DEPARTMENT OF TRANSPORTATION**National Highway Traffic Safety Administration**

[Docket No. NHTSA 2001-11041, Notice 2]

Toyota Motor Corporation, Denial of Application for Decision of Inconsequential Noncompliance

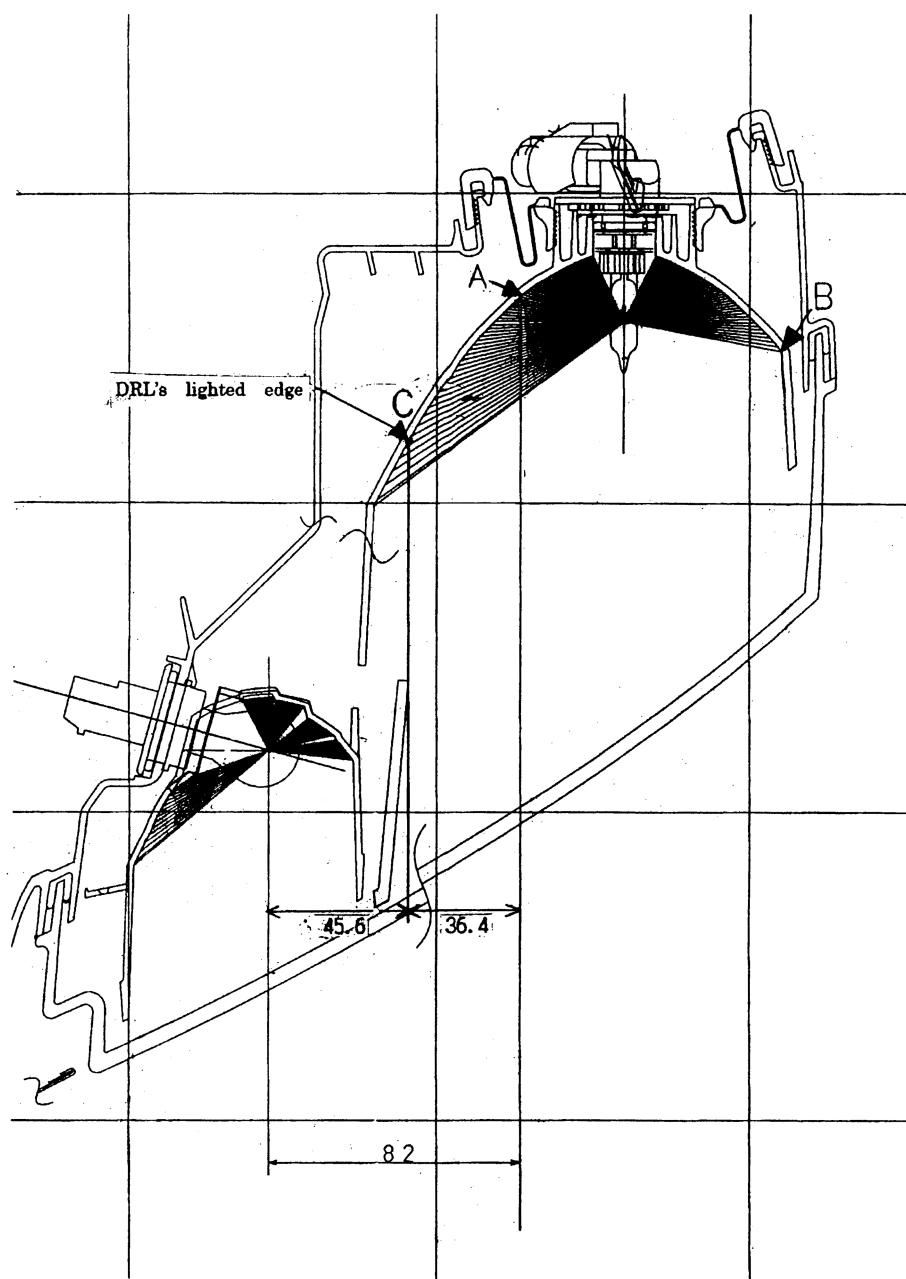
The substantial distance from the turn signal optical center (bulb filament axes) to the DRL's lighted edge is 82 mm, exceeding 80% of the requirements. In this case, the "substantial" distance refers to the distance from the turn signal's optical center to the actual lighted edge "A" [as shown in the figure below], although the theoretical lighted edge is point "C" (45.6mm). In [the figure below], the lighted range from A to C of the reflector emits only light which is parallel to the axis of the DRL, which can only be seen by drivers in oncoming vehicles that are looking along the optical axis of the DRL. However, as one moves off center, this light is no longer visible. Therefore the perceptible DRL's lighted area, except for the unique case where the eye-point is on the optical axis of the DRL, is actually from A to B (as shown in the figure).

Toyota also discussed an alternative method of measuring the distance between the DRL's lighted edge and the optical center of the turn signal. The above figure outlines these two spacing measurements. Toyota stated that the spacing of 45.6 mm between the DRL's lighted edge and the turn signal's optical center (line C to the optical center) would only be seen when looking along the optical axis of the DRL. In other positions, the DRL's lighted edge (line A) would be seen by observers as being 82 mm from the turn signal's optical center. The agency does not find merit in this rationale. First, the distance measured from line A is 18 mm less than the minimum requirement. This is still a significant difference. Second, although the distance from line C to the turn signal's optical center (45.6 mm) may not best represent the DRL's lighted edge in all conditions, it does represent a worst-case scenario. The intent of the standard is to account for all possible viewing locations. Certainly, there will be situations where opposing drivers will be looking along the optical axis of the subject vehicles' DRL. For example, if a vehicle is attempting to make a left turn in front of oncoming traffic, drivers of the oncoming vehicles may be in a position where the turn signal is not visible. Mr. Johnson described a similar situation in his comments.

The agency has reviewed Toyota's rationale for granting the petition and does not agree. Toyota produced almost 100,000 vehicles on which the required spacing between the DRL and turn signal is approximately 55 percent below the minimum required distance. The agency notes that the noncompliance would not have occurred if the DRL had an intensity of 2,600 cd or less. However, Toyota chose not to do this.

In consideration of the foregoing, NHTSA has decided that Toyota has not met its burden of persuasion that the noncompliance it describes is inconsequential to motor vehicle safety, and that it should not be exempted from the notification and remedy requirements of the statute. Accordingly, its application is hereby denied and it must proceed to notify and remedy as required by statute, at no cost to the consumer.
